<b>Well Name:</b> KA SOUSE	<b>Well Location:</b> T26N / R9W / SEC 25 / NESE / 36.45602 / -107.73496	<b>County or Parish/State:</b> SAN JUAN / NM
<b>Well Number:</b> 1	<b>Type of Well:</b> OTHER	<b>Allottee or Tribe Name:</b> EASTERN NAVAJO
<b>Lease Number:</b> 1420603778	<b>Unit or CA Name:</b> KA SOUSE	<b>Unit or CA Number:</b> NMNM87124
<b>US Well Number:</b> 3004505662	<b>Well Status:</b> Producing Gas Well	<b>Operator:</b> HILCORP ENERGY COMPANY

**Notice of Intent**

**Type of Action:** Plug and Abandonment

**CONDITIONS OF APPROVAL**

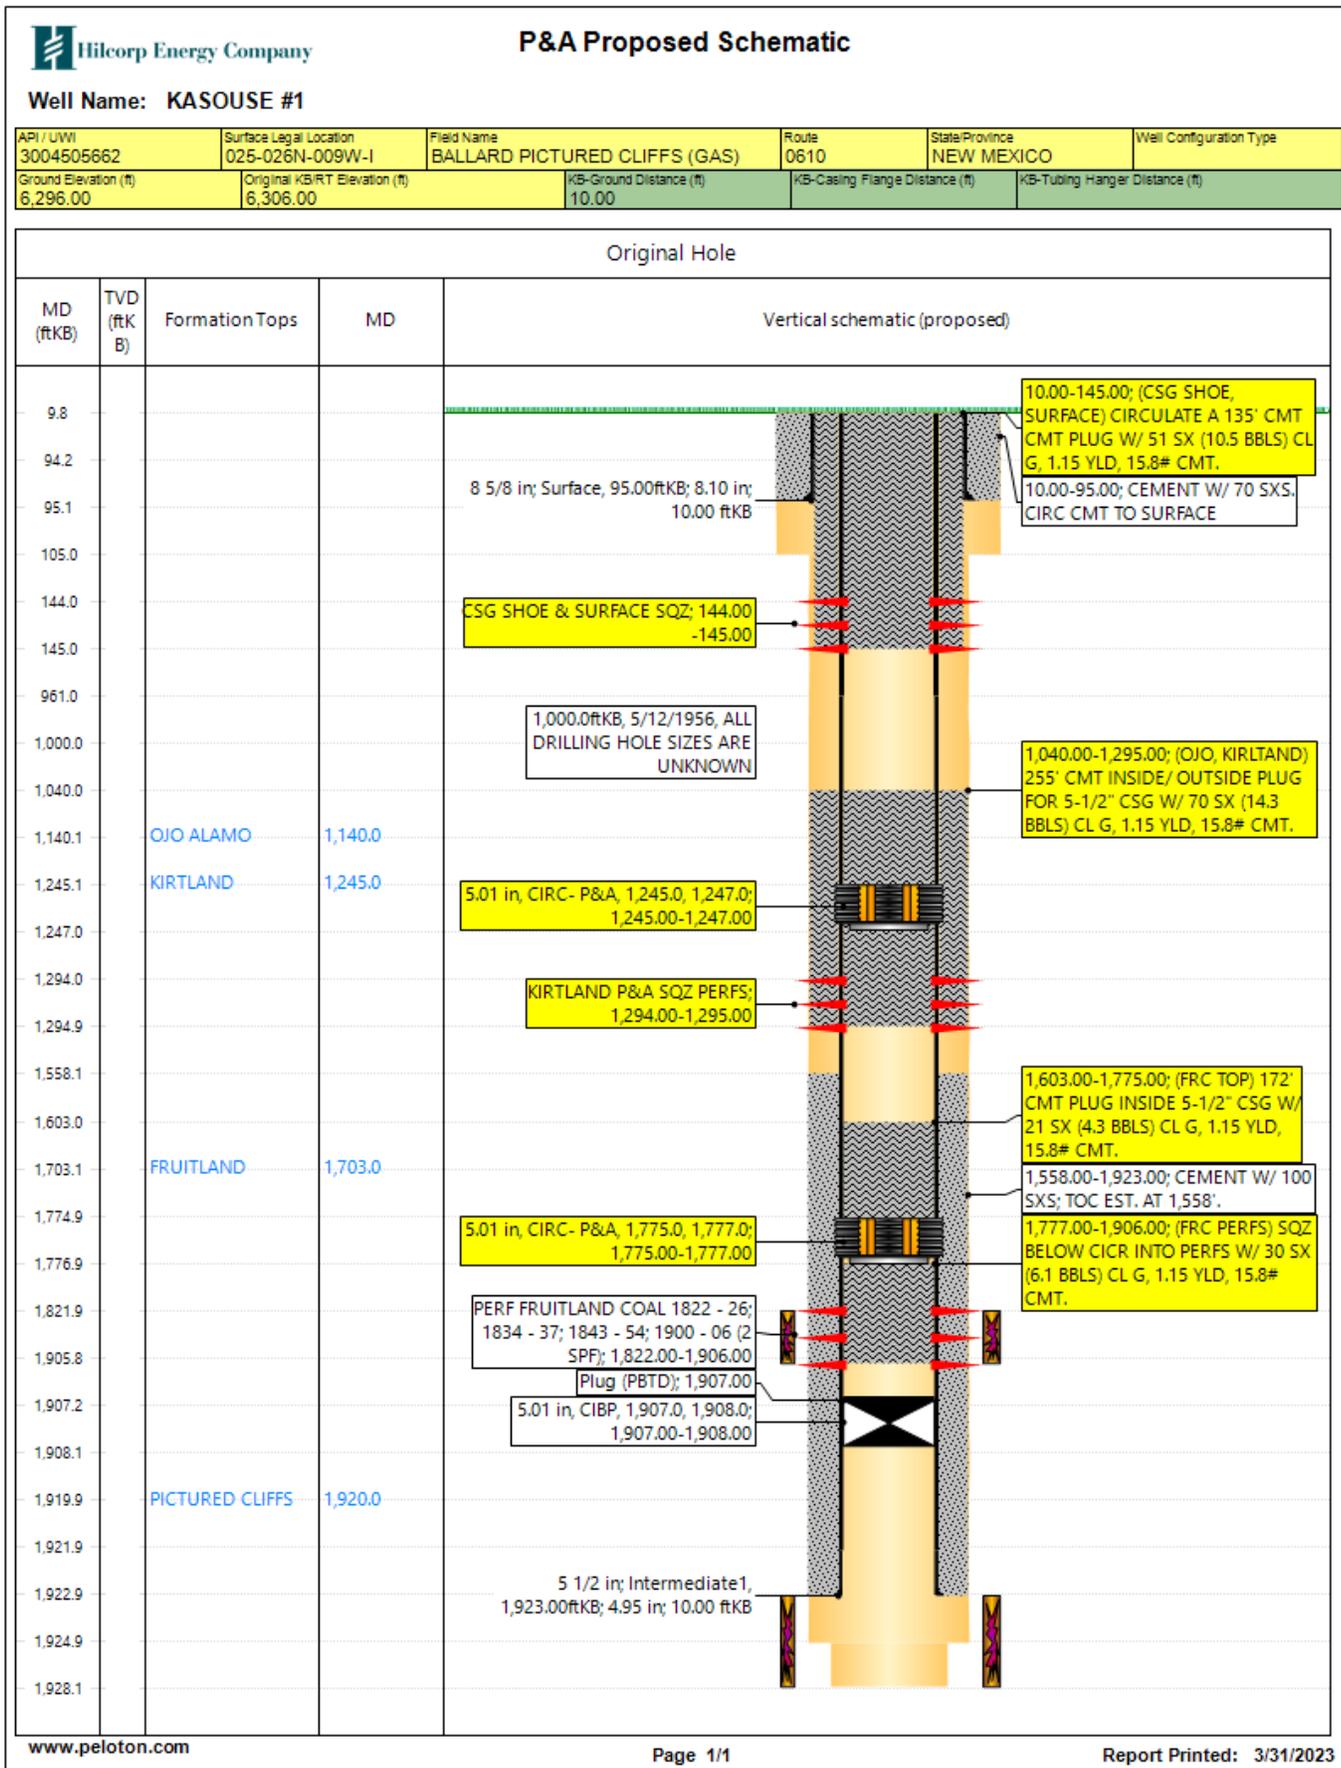
1. Plugging operations authorized are subject to the attached "General Requirements for Permanent Abandonment of Wells on Federal and Indian Lease."
2. The following modifications to your plugging program are to be made:
  - a. Change the Plug 1 TOC to 1686' to account for the BLM Fruitland formation top.
  - b. Change Plug 2 by perforating at 1298', setting the CICR at 1248', and running cement from 1298' to 1034' to account for the BLM Kirtland Shale and Ojo Alamo formation tops.
3. Farmington Office is to be notified at least 24 hours before the plugging operations commence at (505) 564-7750.

- Change the Plug 1 TOC to 1686' to account for the BLM Fruitland formation top.  
 -Change Plug 2 by perforating at 1298', setting the CICR at 1248', and running cement from 1298' to 1034' to account for the BLM Kirtland Shale and Ojo Alamo formation tops.
